Product: TPT 3001

**TANDBERG**<sup>®</sup>

Service Information

## MODIFICATIONS

New dial pointer drive cord  
-----

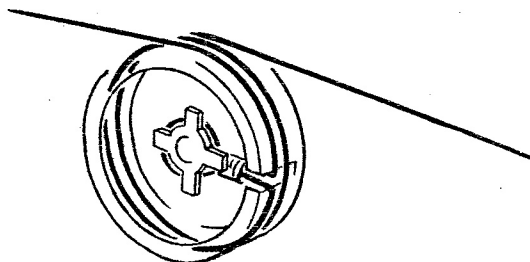
To avoid problems related to the fixing of the dial pointer drive cord, reported from various markets, the following change must be made:

1. Change the cord mounting drawing in the service manual paragraph 1.2 according to new drawing. (Below)
2. Remove old dial pointer drive cord.
3. Mount the new cord according to drawing.
4. Mount the dial pointer according to paragraph 1.2 of the service manual.
5. Position the pointer and realign tuner dial according to service manual page 9, figure 11.
6. The new cord may be ordered from Tandberg A/S' Service Department on Part No. 997004

Part of tuning system 1, PC board seen from the solder side.

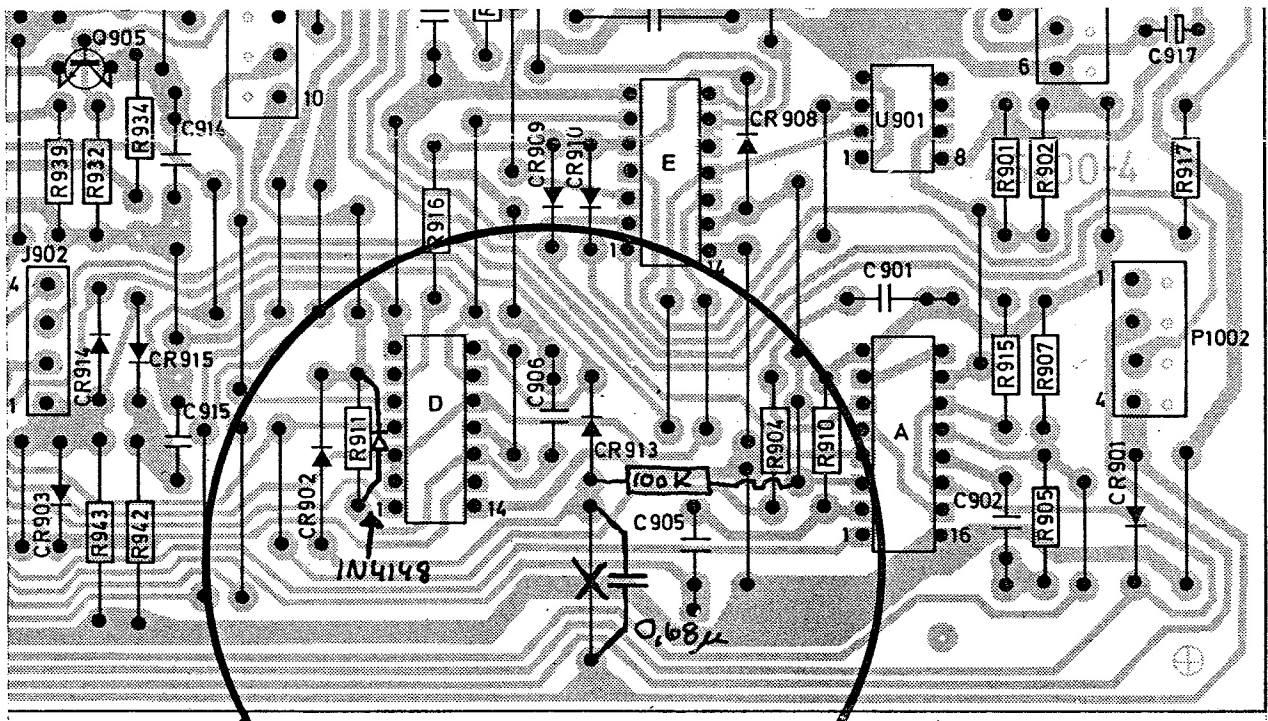
Symtom: Programme loss, continuous search.

Cause : Replace strap facing anode of CR 913 with a condenser  
0,68  $\mu$ F 100V foil part No. 282064 (15 mm between  
component legs).

Insert a 1/3W 100 kohms resistor between the anodes of  
CR 908 and CR 913, part No. 280944.

Insert diode 1N4148 parallel to R 911, the anode side  
facing pin 12 of U 905, part No. 247007.

Touch sense board, component side

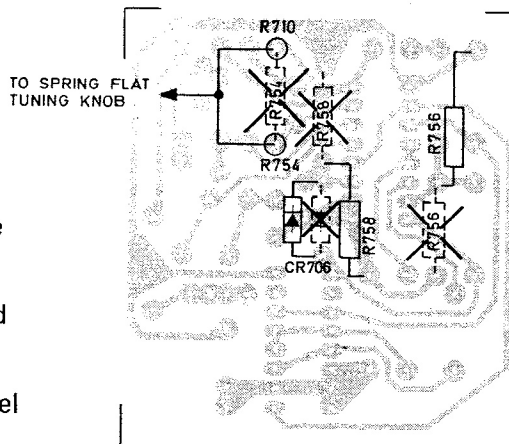
In addition to the previous modification we will also recommend that you do the following modification on the tuning sense board as shown in the figure. This modification makes the receiver less sensitive for external radiation fields.

- CR706 is turned in opposite direction
- R756 and R758 are connected as shown in the figure
- R754 is replaced with 2 pcs. of 330 kohms and a wire is soldered to the center of the two 330 kohms. The other end of the wire is connected to the flat spring behind the flywheel on the tuning knob.

Touch sense board, component side

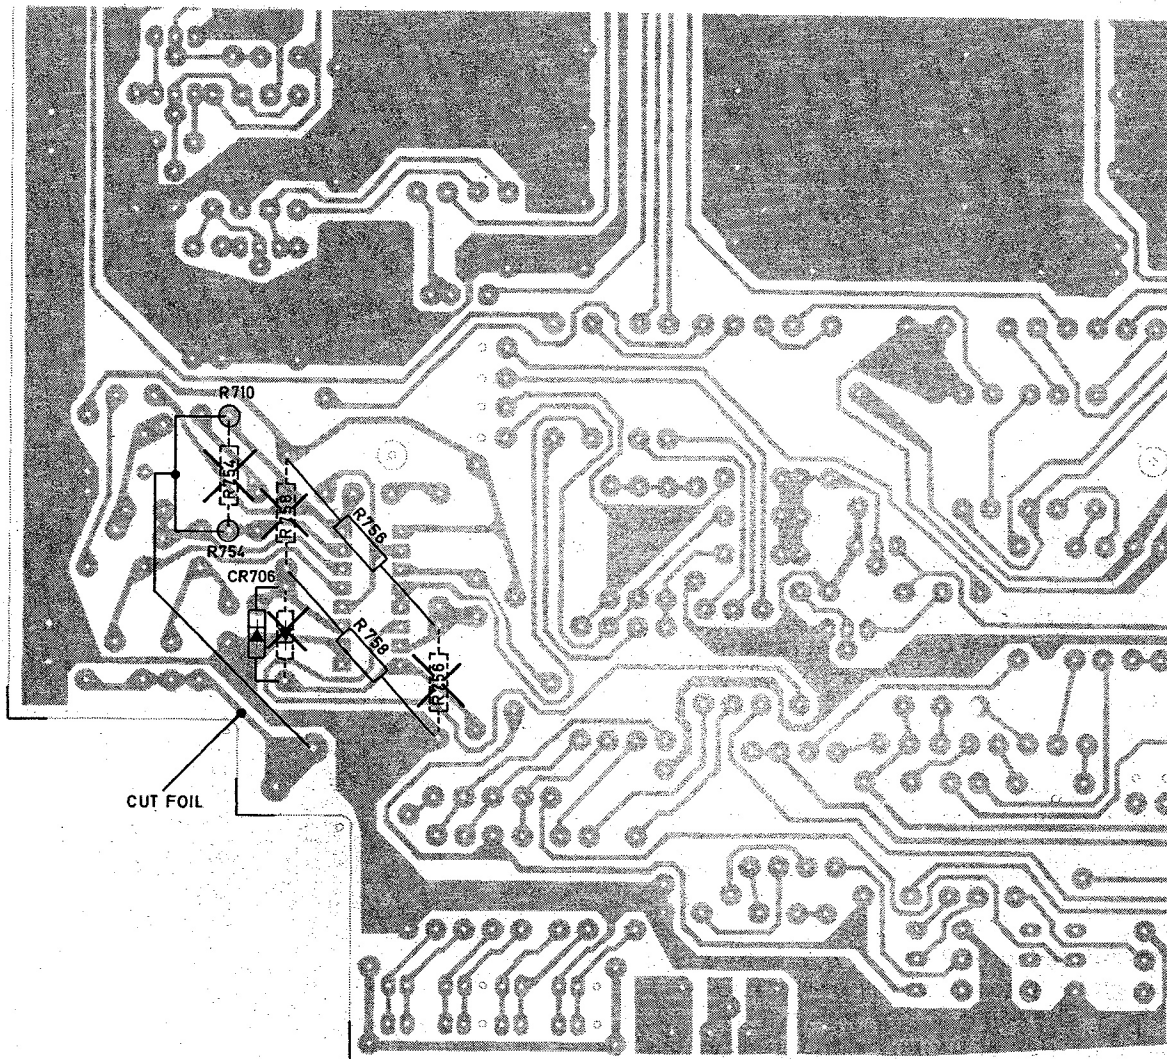
2. This modification also makes the receiver less sensitive for external radiation fields.

On receivers with serial No. from 01077 to 01691 the following modifications should be carried out:

- CR706 is turned in opposite direction
- R749, change the value to 47 kohm
- R750, change the value to 1 Mohm
- R751, change the value to 1 Mohm
- R752, change the value to 820 kohm
- R753, change the value to 680 kohm
- R755, change the value to 330 kohm
- R754 is replaced with 2 pcs. of 330 kohms and a wire is soldered to the center of the two 330 kohms. The other end of the wire is connected to the flat spring behind the flywheel on the tuning knob and the foil is cut as shown in the figure.
